Subject: MHI's Responses to US-APWR DCD RAI No.161-1812 Revision 0

Responses to Request for Additional Information No.161-1812
Revision 0

**US-APWR Design Certification
Mitsubishi Heavy Industries
Docket No. 52-021**

Figure B 3.0-1
Configuration of Trains and Systems

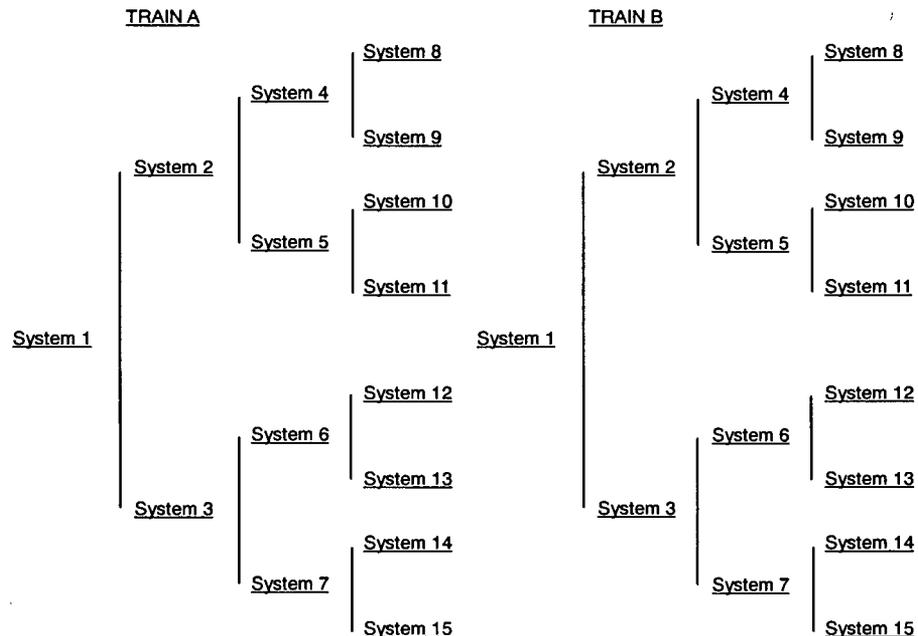
Provide examples of a loss of safety function related to cross train checks in the USAPWR TS LCO 3.0.6 BASES.

The related Bases will be revised as this RAI pointed out.

The DCD will be revised to include examples of a loss of safety function related to cross train checks as shown in Attachment 2.
